DRESDEN 2

APPL FOR AMDT TO OL RE SINGLE LOOP OPERATION
WITH THE RECIRCULATION LOOP SUCTION &
DISCHARGE VALVES OPEN.

DESCRIPTION AND SAFETY ANALYSIS OF PROPOSED CHANGES TO APPENDIX A, TECHNICAL SPECIFICATIONS OF FACILITY OPERATING LICENSES DPR-19, DPR-25, DPR-29 and DPR-30

FIGURE 1: RECIRCULATION SYSTEM

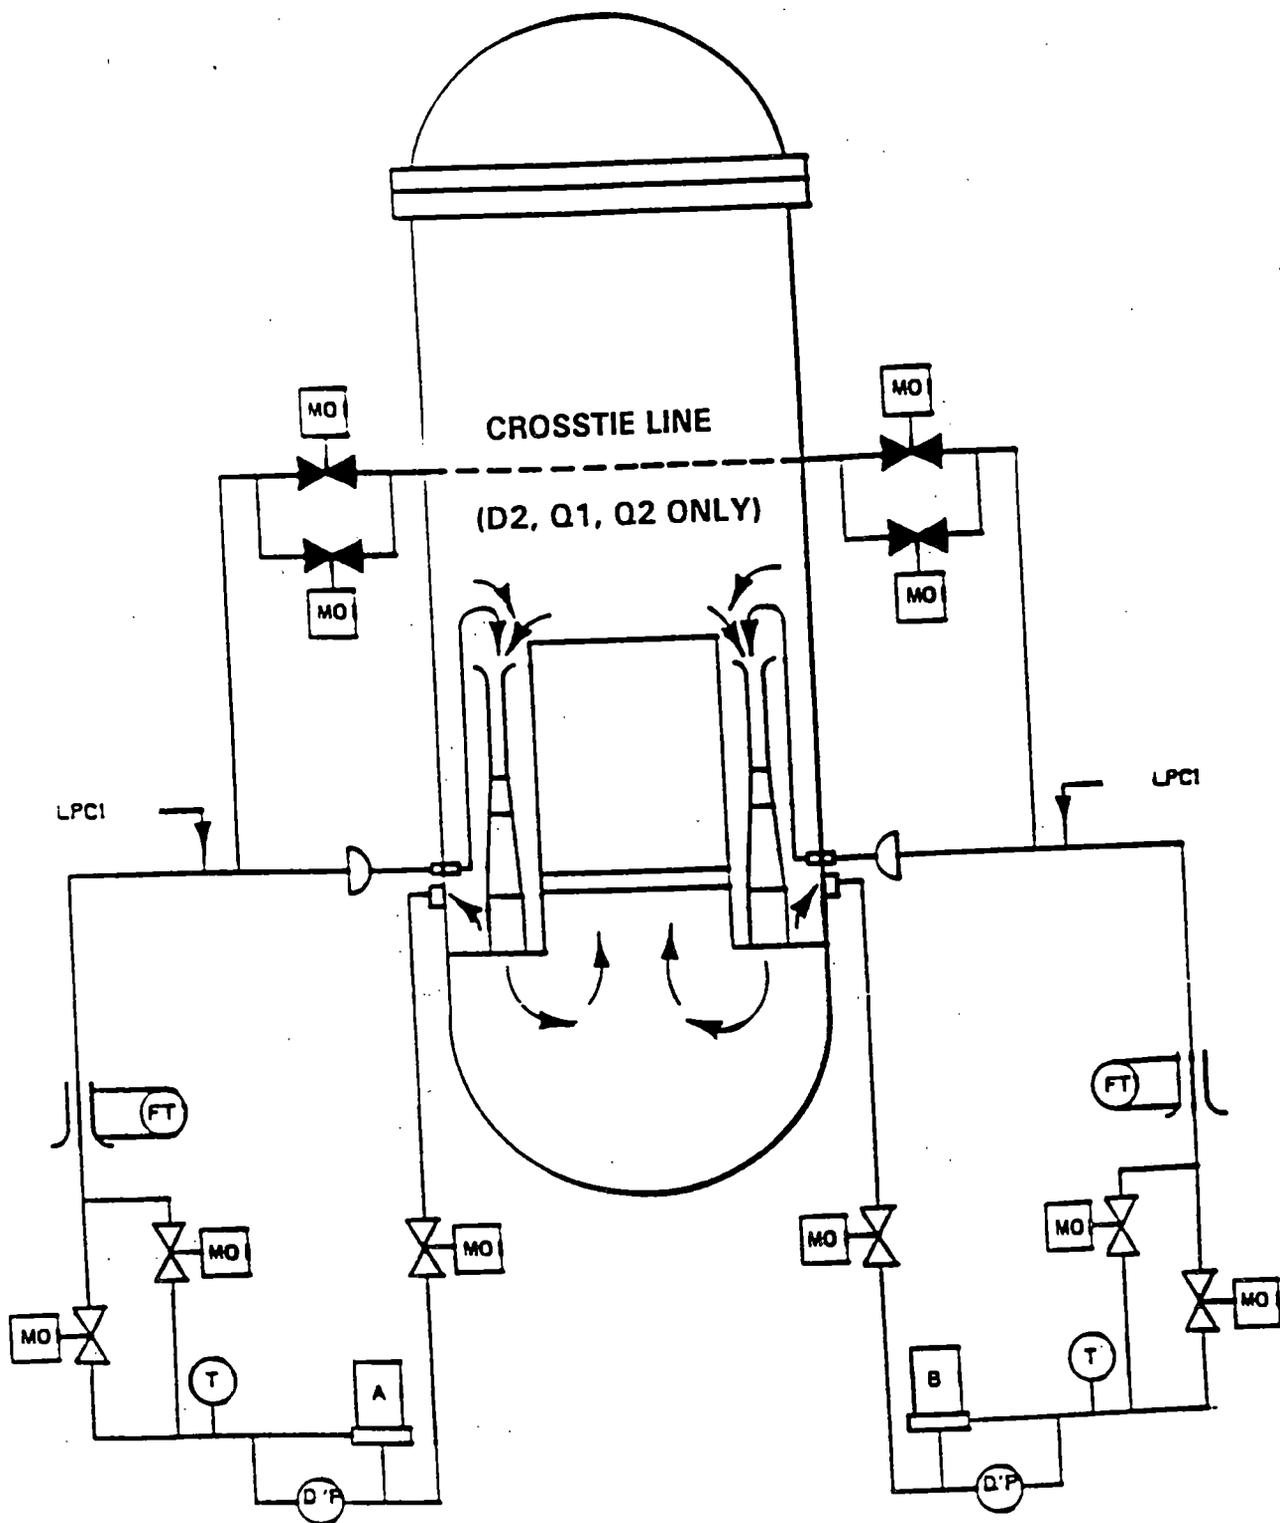
During SLO, Section 3.6.H.3.e. of both the Dresden and Quad Cities Technical Specifications currently requires the closing and electrical isolation of the suction valve of the idle recirculation loop. This requirement is waived when the idle loop is being prepared for return to service. The purpose of this requirement was to prevent the partial loss of Low Pressure Coolant Injection (LPCI) flow through the recirculation pump and into the downcomer region during a Loss-of-Coolant Accident (LOCA). As shown in Figure 1, the LPCI system ties into the recirculation system downstream of the recirculation pump discharge valves. By closing either the recirculation loop suction or discharge valve, the core is reflooded using LPCI flow which is forced through the jet pumps into the lower plenum of the reactor and up through the core. Otherwise, a portion of the flow would be directed through the recirculation pump and into the downcomer region, bypassing the reactor core.

According to GE, closing the suction valve is a redundant action because LPCI is provided with a means by which it selects the intact recirculation loop and automatically closes that recirculation loop's discharge valve (Reference (i) - Attachment E). This ensures reflood capability by directing LPCI flow through the jet pumps and into the lower plenum (see Figure 2 for LPCI Loop Selection Logic Schematic). The LPCI loop select logic performs this function whether one or both recirculation pumps are running.
